Calvert Cliffs Nuclear Power Plant, Units 1 and 2
Renewed Facility Operating License Nos. DPR-53 and DPR-69
Docket Nos. 50-317 and 50-318

Subject: Response to Request for Additional Information to License Amendment
Request - Revision to Technical Specification 5.5.7, Reactor Coolant Pump
Flywheel Inspection Program

Response to Request for Additional Information

Revision to Technical Specification 5.5.7,
Reactor Coolant Pump Flywheel Inspection Program
Docket Nos. 50-317 and 50-318

Graph 1

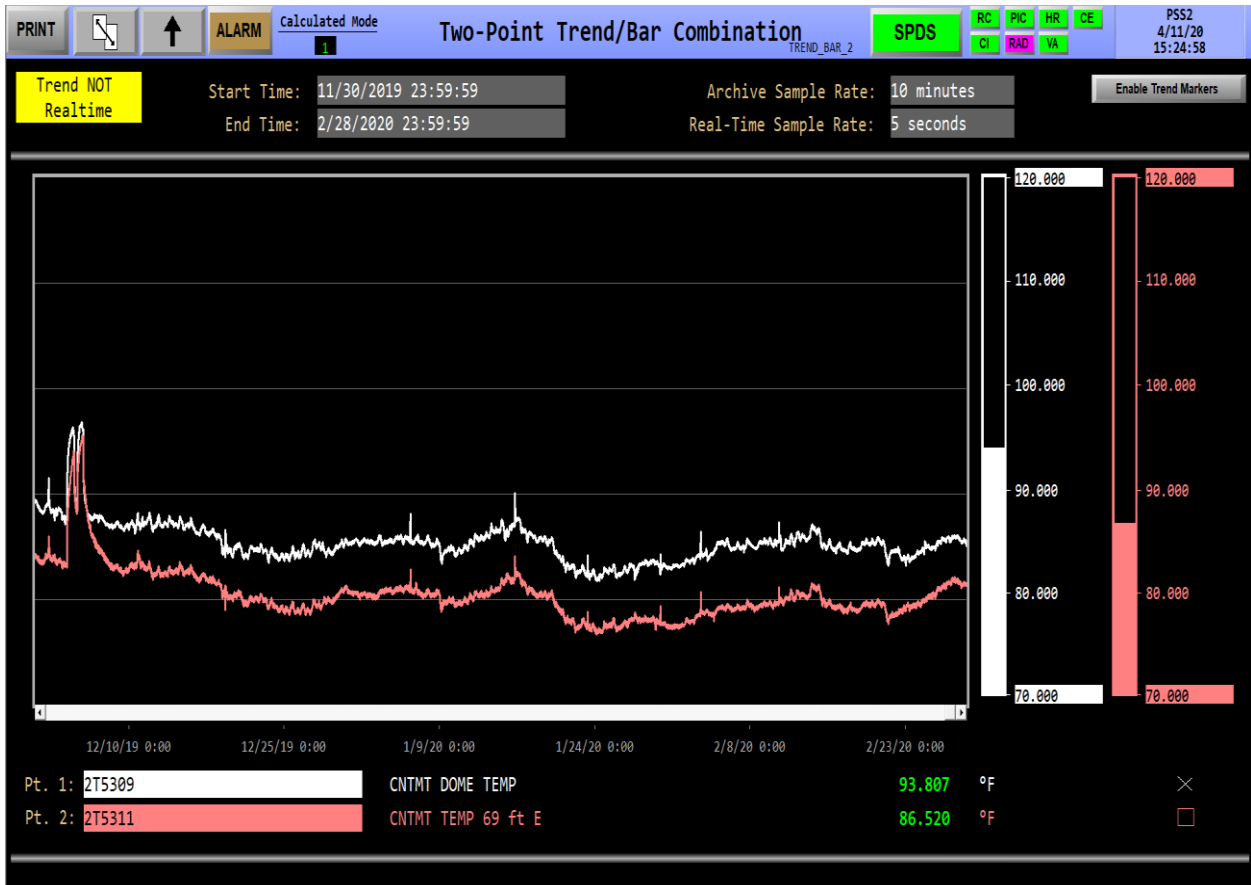
Provide a basis to confirm that the medium temperature will be 70°F or higher consistently, or provide the (RT_{NDT}) of the flywheel materials such that the medium temperature as described in the UFSAR, when coupled to (RT_{NDT}) values remain bounded by the TR.

Attached are graphs indicating the daily containment temperature during this past winter months as well as the daily containment temperature during summer months. From these attached graphs it shows that the choice of 70°F is conservative and is well below average containment temperatures experienced during operating conditions. Even with this conservative value, the calculation resulted in large critical crack lengths.

Graph 1 is taken from Unit 2 during operation this past winter (December 2019 through February 2020) and shows temperature in containment at the 69-foot elevation in containment and temperature near the top of containment dome. Containment temperatures during the coldest part of the year remained above 70°F.
